# NORTHUMBERLAND DEVELOPMENT PROJECT **HOTEL**

**S73 APPLICATION**

THHTL-F3A-XX-XX-RP-A-0006

**DESIGN AND ACCESS STATEMENT ADDENDUM UPDATE**

**FIGURE 4.** Proposed Scheme Revision - Diagrammatic West Elevation

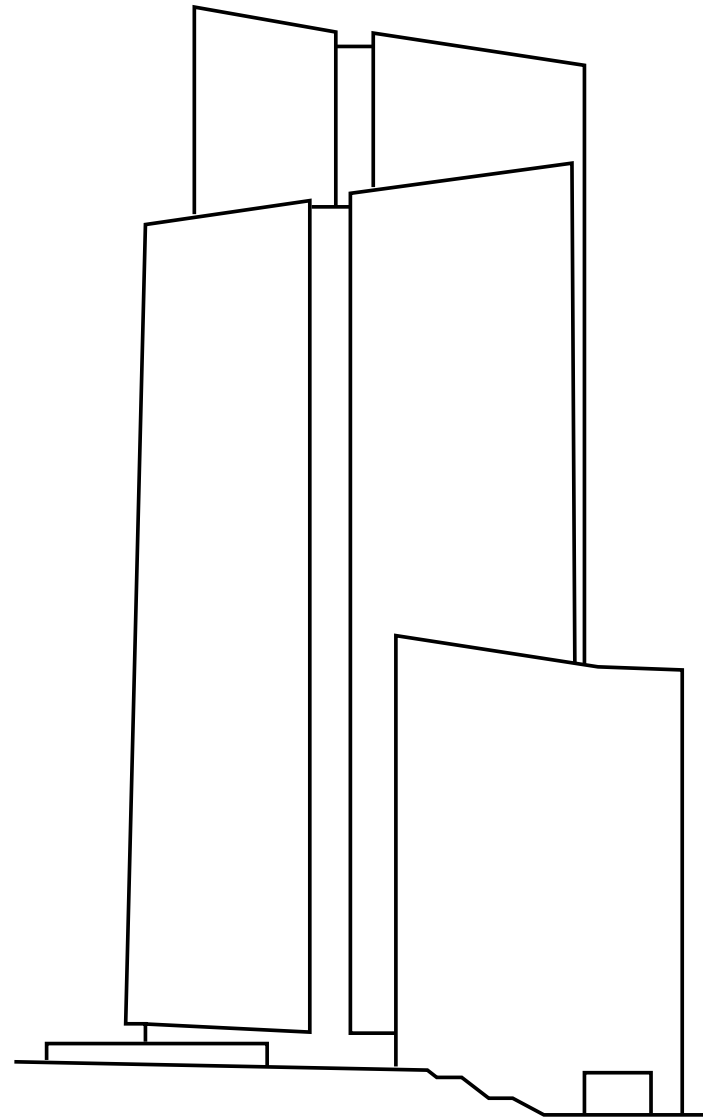
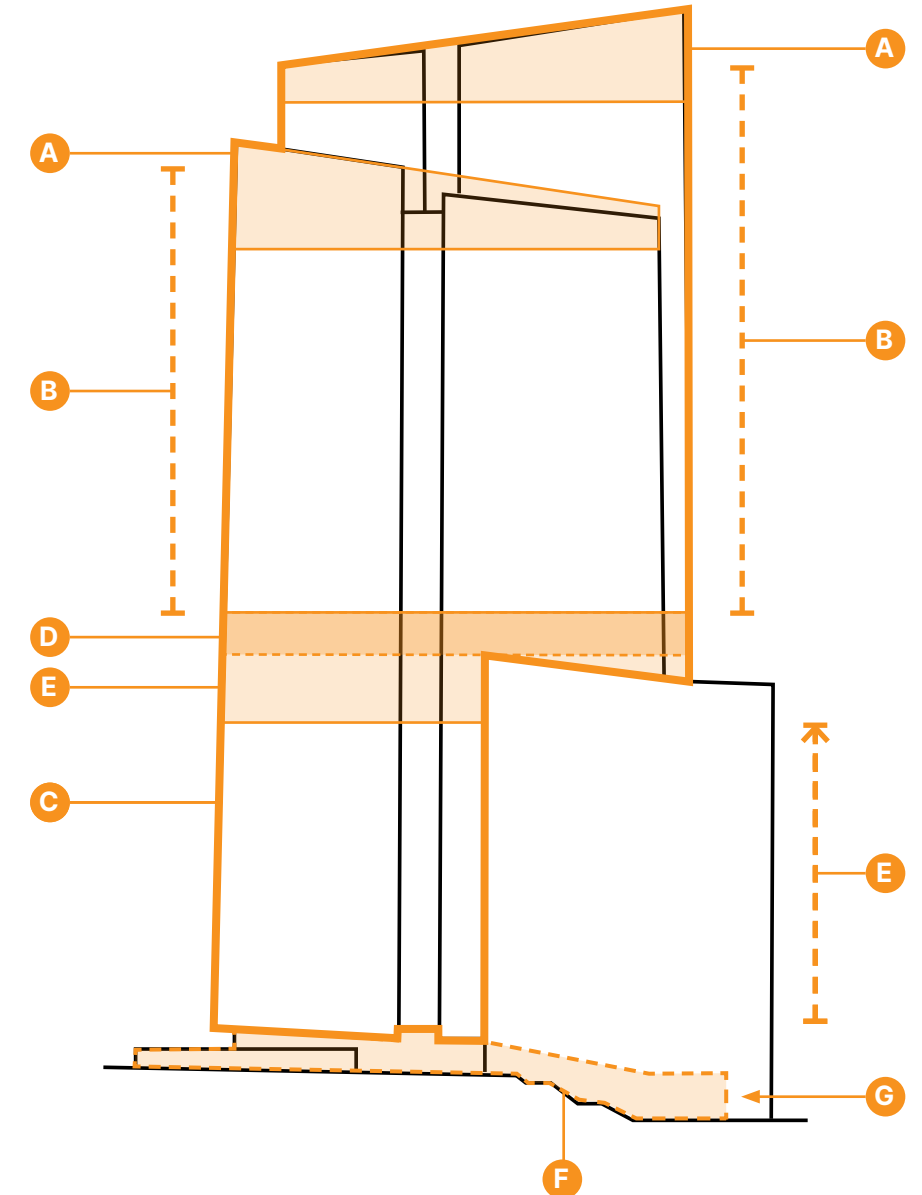
In response to the post-submission consultation process, the following design revisions are proposed: -

- A. Top of Tower** - Top of 'planar blades' mirrored and articulated to accentuate its role as a landmark for the area, whilst maintaining same overall height as per the submitted scheme.

- B. Balcony Materiality and Planters** - Residential balconies have an upstand to the inside of the balustrade to conceal planters. Bronze balustrades create a visual connection between 'folding blades' and top of the tower.

- E. Hotel and Hotel Amenity Floors** - The number of hotel rooms has been reduced from 20 to 18 rooms per floor (now spanning Levels 02-11), still accommodating a total of 180no. hotel rooms. Updates to hotel amenity layout provide improved hotel guest experience.

**FIGURE 10.** Proposed Scheme Revision - High Road Elevation (West)

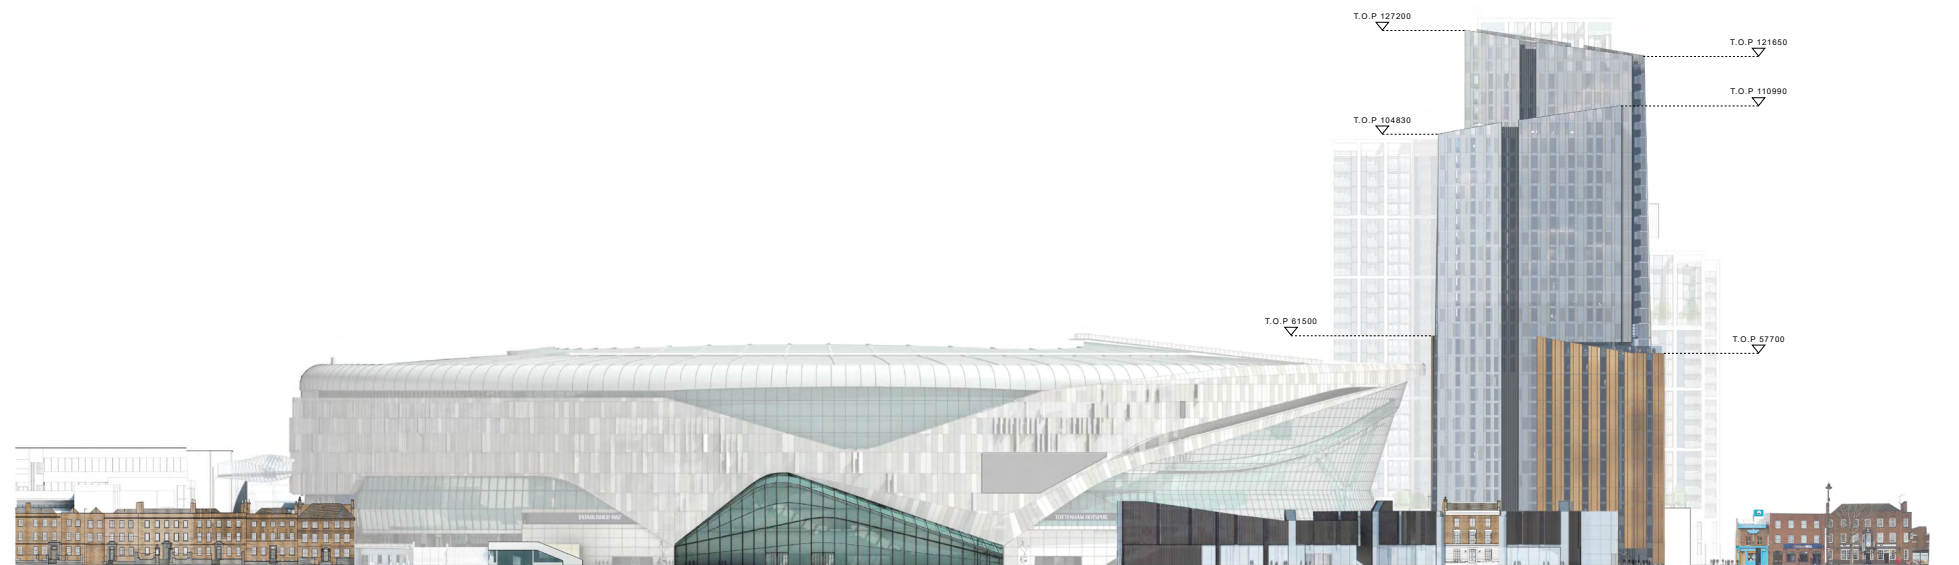
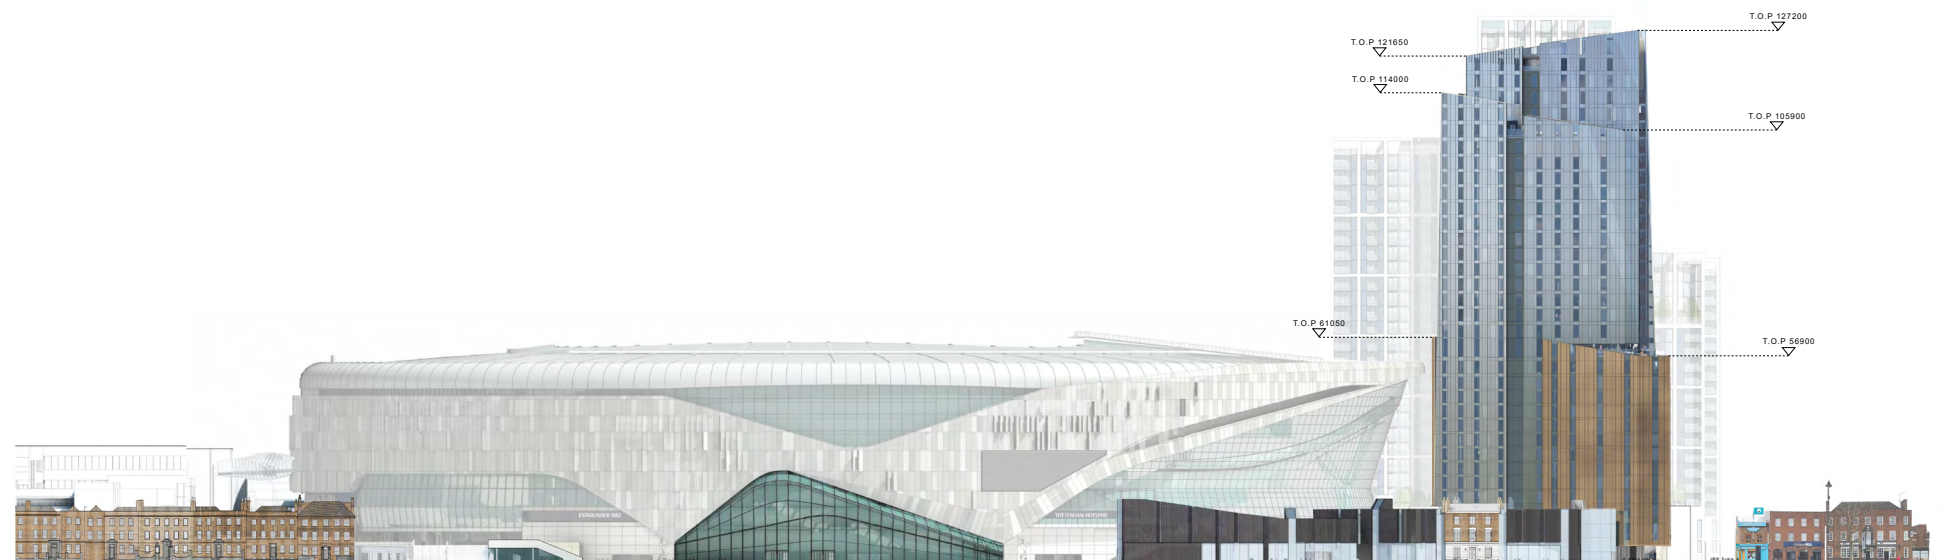
- Refinement to the top of the building to accentuate its role as a landmark for the area.
- Top of 'planar blades' mirrored, now ascending towards Central London to south.
- The 'lantern' at its apex, provides a spire like termination to the tower when viewed from the south along the High Road.

- Distinctive angled silhouette along with slenderness and dynamism leads the eye upwards, from the base of the building to the top.
- A 'crown' to the top of the building, concealing all maintenance and plant equipment, photovoltaic panels, and lift core and overruns.
- Better meets aspirations for an elegant landmark.
- TVIA assessment concludes that the tower continues to be a significant enhancement to the nearby townscape character areas and in townscape views.

**FIGURE 17.** Proposed Scheme Revision - View of Top of Tower from South West

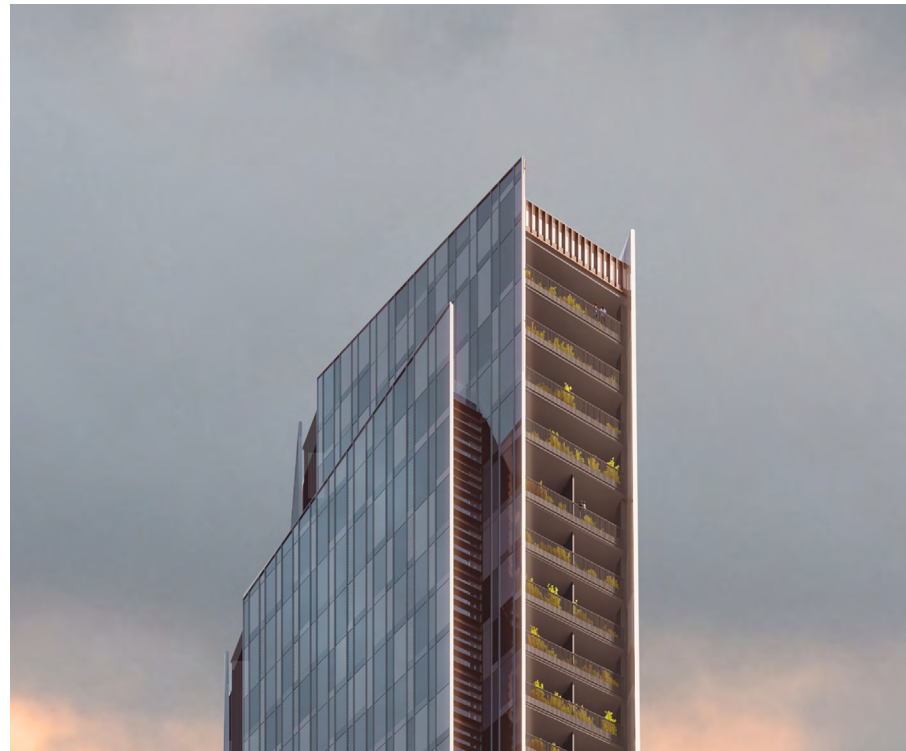
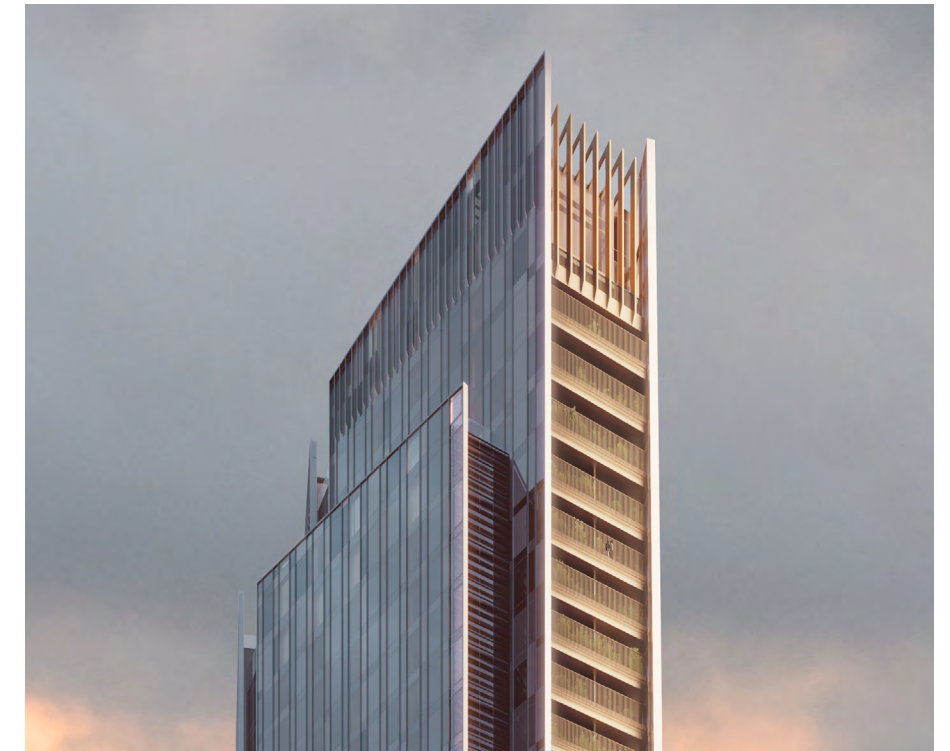
- External design to be taken to the next level of detail, articulating fins and bringing more delicacy in the changes of material to help the massing appear less solid and grey.

- Increased depth and density of fins to the top of the blades, on eastern and western elevation.
- Refinement and articulation of projected fins, angled and mirroring the direction of the top of the blades. Base of these elements chamfered to create a slender connection to mullions beneath.
- External lighting strategy reinforces the vertical linearity of the façade at night.

- Brings more delicacy to help massing appear less solid and grey.
- Halo illumination to the upper most portions of the blades creates a lightness to the building.
- Note that increased depth of projecting fins does not add or improve building energy efficiency or performance.

**FIGURE 22.** Proposed Scheme Revision - Top of Building Bay Study Section

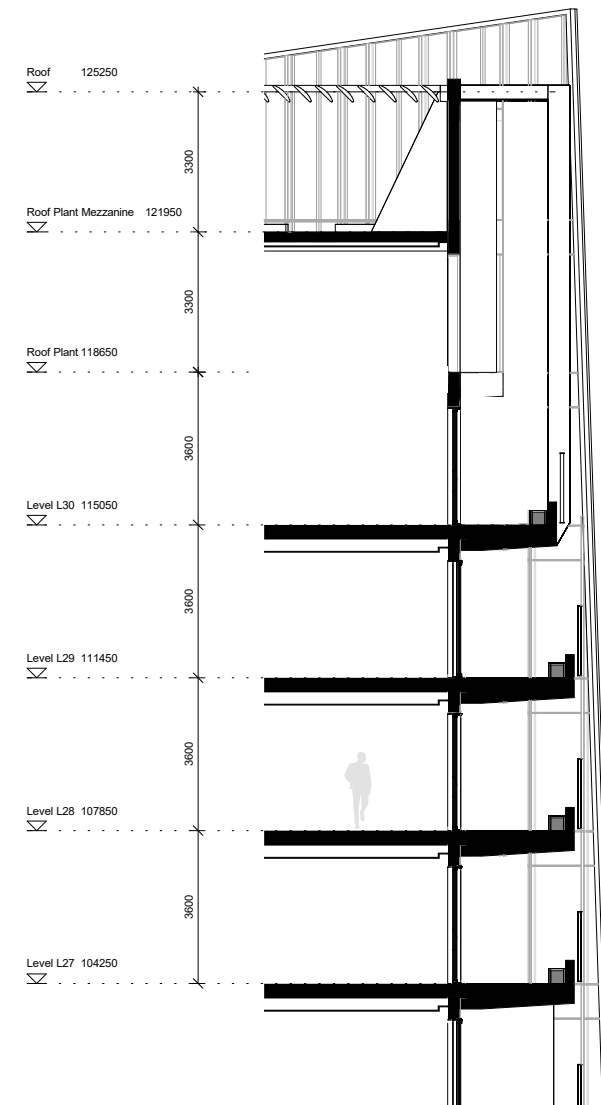
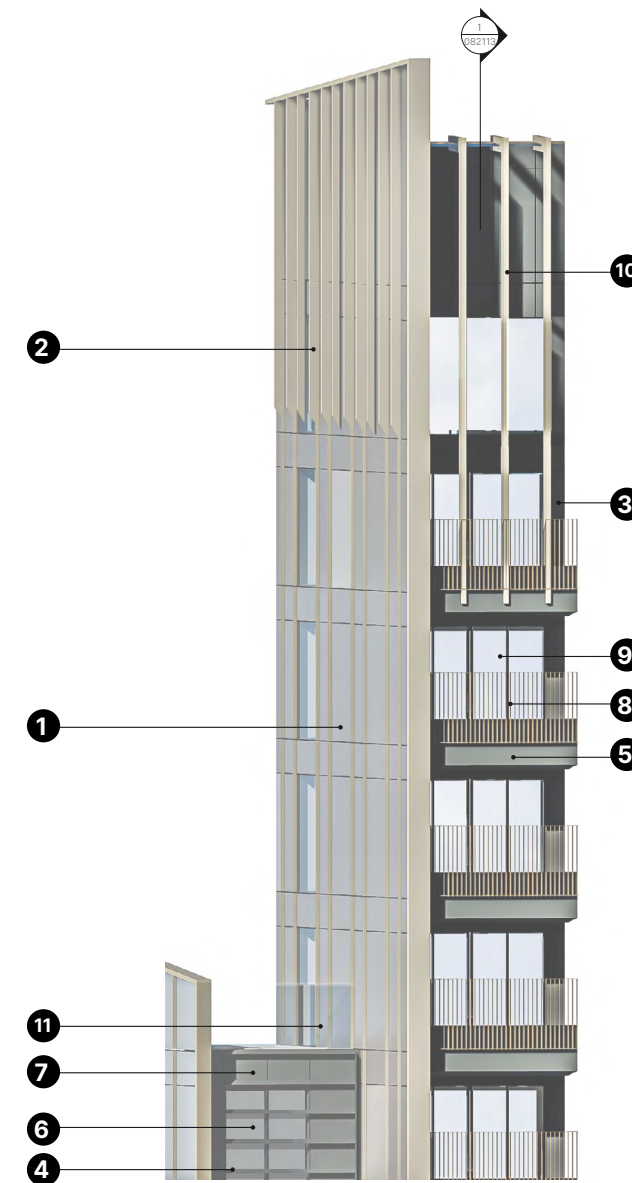
- ❶ Planar Blades  
Solid panel - aluminium (anodised effect finish)
- ❷ Planar Blades  
Light bronze coloured projected aluminium mullions
- ❸ Recessed Infill - East and West  
Dark grey coloured aluminium panel
- ❹ Recessed Infill  
Dark grey coloured aluminium projected louvres or brise-soleil
- ❺ Recessed Balconies  
Dark grey aluminium upstand
- ❻ Glass vision panel
- ❼ Recessed Infill  
Dark grey coloured back-painted opaque glass spandrel panel
- ❽ Recessed Balconies  
Bronze coloured vertical metal railings and balustrades
- ❾ Recessed Balconies  
Dark grey coloured aluminium glass sliding door
- ❿ Recessed Infill N/S  
Illuminated dark grey aluminium panel with projected fins
- ⓫ Vision Glass Screen

**FIGURE 26.** Proposed Scheme Revision - Longitudinal Section (looking West)

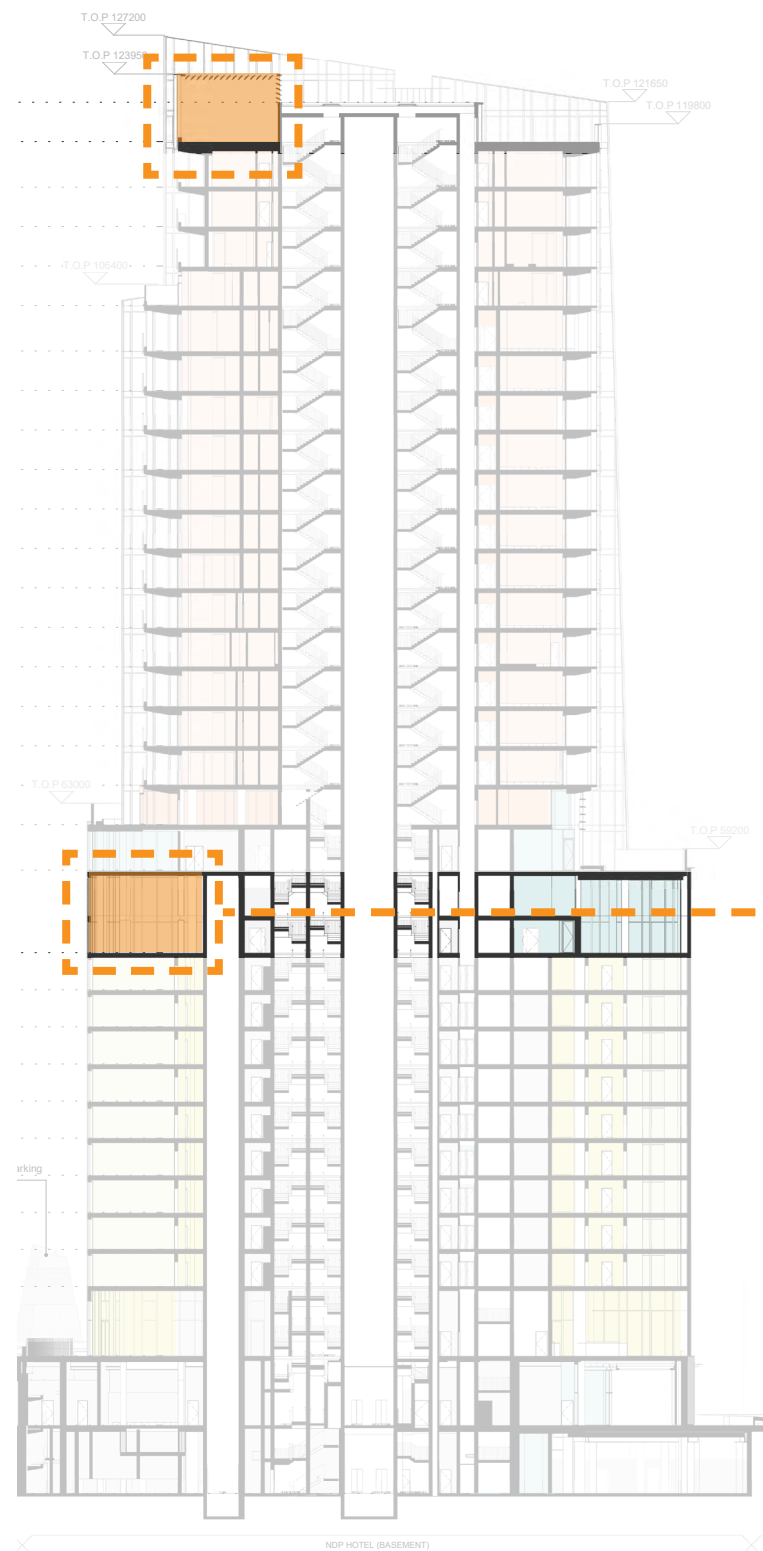
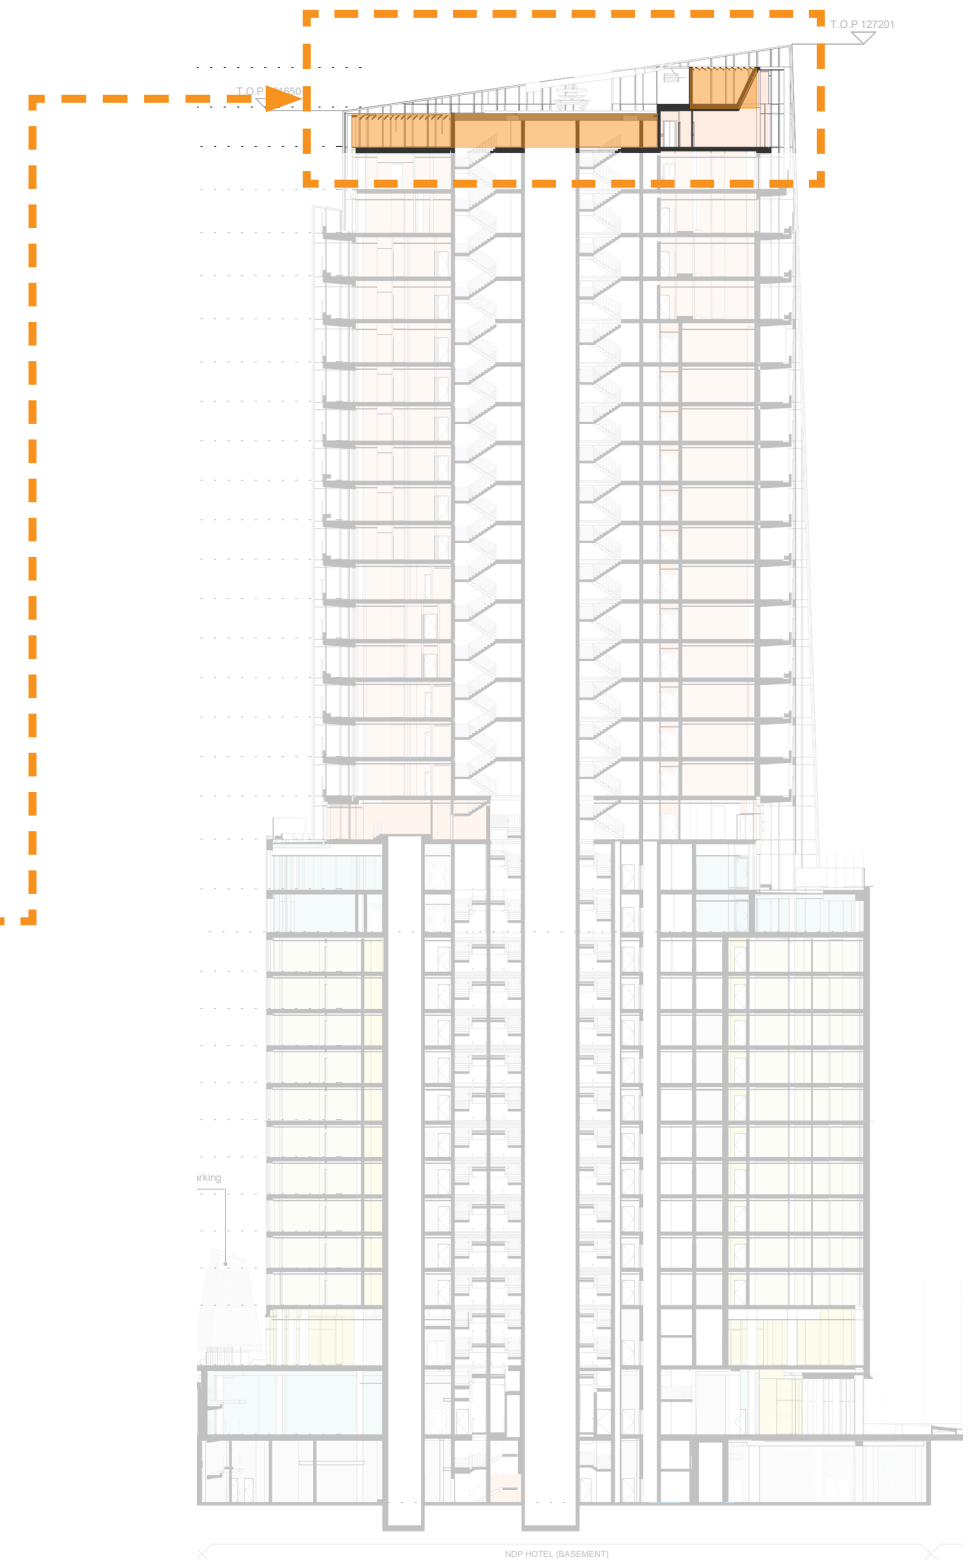
- Although the Energy Strategy includes connection to the district energy network, safeguarding of plant spaces reserved for air source heat pumps should be accounted for in case the energy network is not available at time of construction.

- Majority of mid-floor plant equipment moved to roof levels.
- Plant equipment located externally, within louvred screen providing adequate space for ventilation.

- All plant equipment is concealed at roof level, negating the need for ventilation/ louvred panels across large portion of the facade.
- Maintenance equipment and photovoltaic panels remain hidden from view, aiding and preserving the impact of the clean and sharp geometry of the blades.
- Omission at mid-level allows for an Increase in Gross Internal Area for hotel amenity spaces where plant equipment was previously located.
